# service bulletin

No. 94-13

## Power Trim Partial Leak Down at Maximum Trim – 75 thru 125

### Mariner and Mercury

**Figure 1. Date Code Locations:**

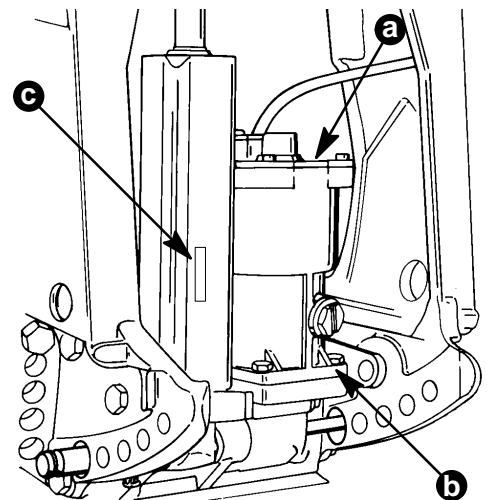
### Date Code on Power Trim

- a - Label on top cover of motor.
- b - Motor reservoir flange.
- c - Embossed into the caution decal on trim/tilt cylinder (this might be difficult to read).

**Figure 2. Trim/Tilt Cylinder Assembly.**

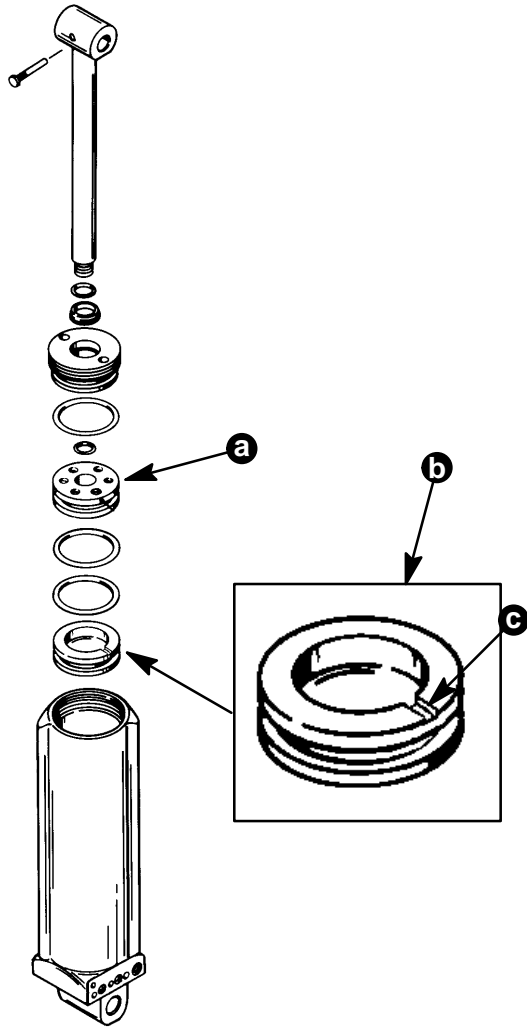
Single ram power trim units are designed to trim the outboard to a maximum of 20 degrees. Some units, when trimmed to the maximum 20 degree limit, will leak down approximately 5 degrees and then hold. The leak down will ONLY occur while the boat is under power. The cause for the 5 degree leak down is the lack of a fluid passage between the shock piston and the memory piston. For other leak down symptoms, refer to service bulletin 93-22A.

Disassemble the power trim/tilt ram assembly (refer to the service manual) and remove the memory piston. Cut a small groove .020 – .040 inch (.5 – 1 mm) deep across the top face the memory piston (figure 2). The groove will allow oil passage when the shock piston and memory piston are in contact. The groove can be easily created with a hacksaw or triangular file. Remove all burrs and filings from the memory piston. Reassemble the trim/tilt ram assembly using new O-rings and seals.

a - Shock Piston.

b - Memory Piston.

c - .020 – .040 Inch (.5 – 1 mm) Groove.

The shock piston has a groove to allow fluid passage beginning with power trim date code 14183 and estimated serial number 0G152529. The memory piston remains the same and does not have a groove across the face.
